INDEX MAP
TRACT NO. 22332
P.C. 3958

PROFILE ALIGNMENT AND GRADE OF P.C. 3958
SANITARY SEWERS PAGE 1
TO BE CONSTRUCTED IN
(24,001)
TRACT Nº 22332
(28)
PRIVATE CONTRACT NO. 3958
W.S. 38
16 SHEETS; 28 PAGES
SCALE: 1 INCH = 100 FEET; 1" = 6' HORIZ. APRIL, 1956
PREPARED IN THE OFFICES OF
By Ellsworth J. Epperson
R.E. / C. E. NO. 5618
FOR LEGEND SEE PLAN NO. S-A-64

RC.3958 PAGE 20

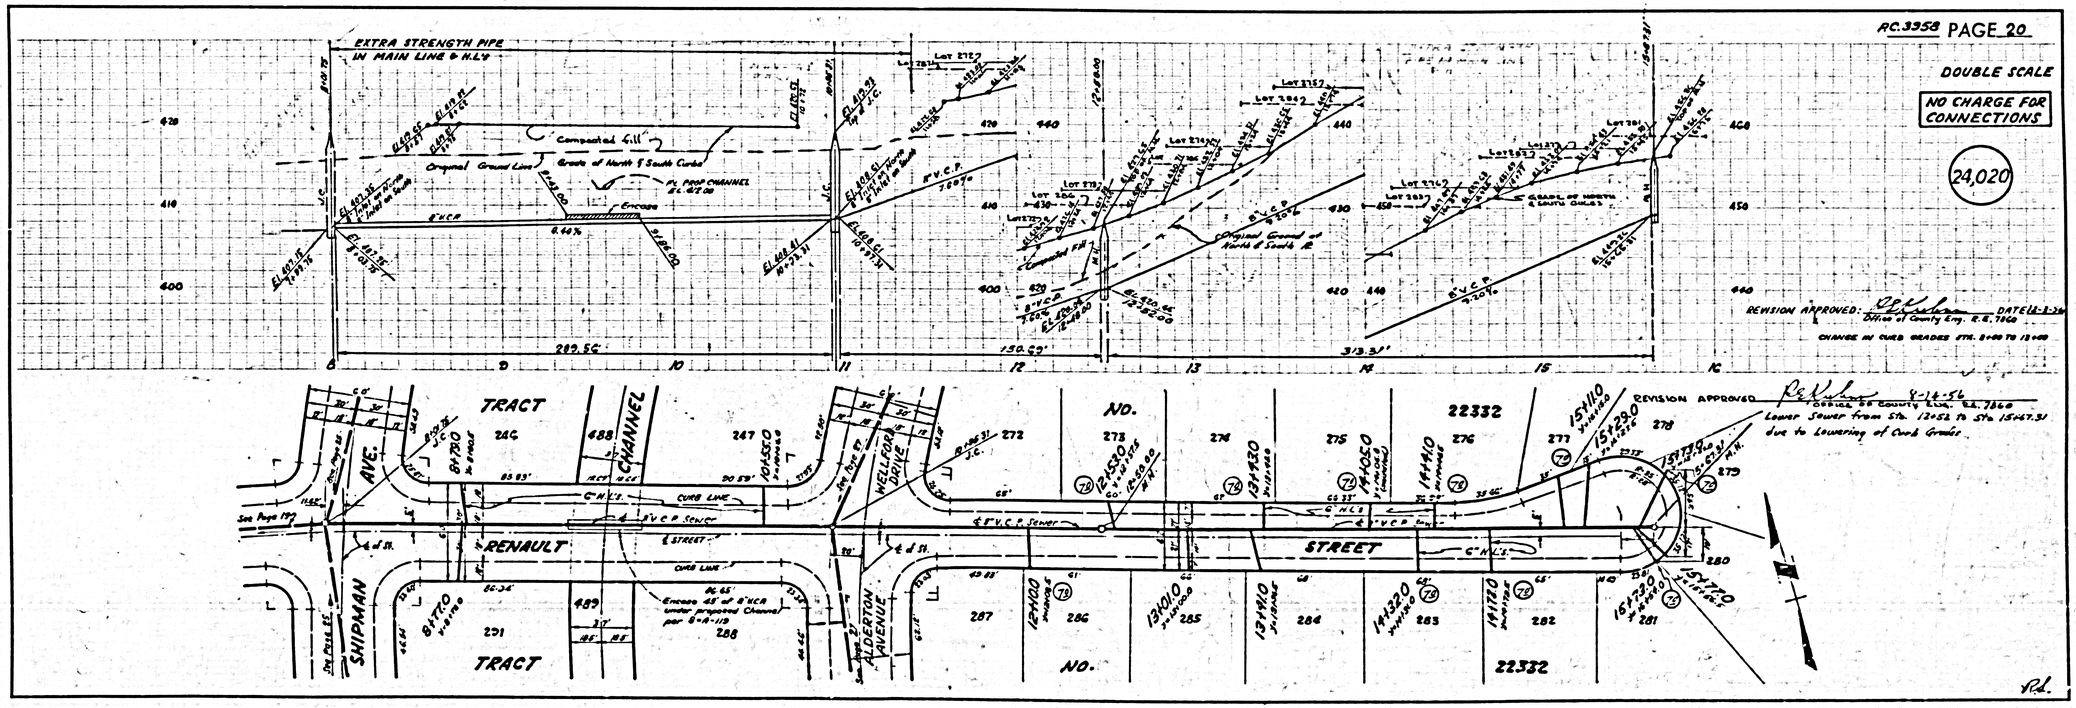
REVISION APPROVED: [signature] DATE 12-3-56
Office of County Eng. R.E. 7860
CHANGE IN CURB GRADES STA. 8+00 TO 13+00

REVISION APPROVED [signature] 8-14-56
COUNTY OF COUNTY ENG. RE. 7860
Lower Sewer from Sta. 12+52 To Sta 15+47.51
due to Lowering of Curb Grades.
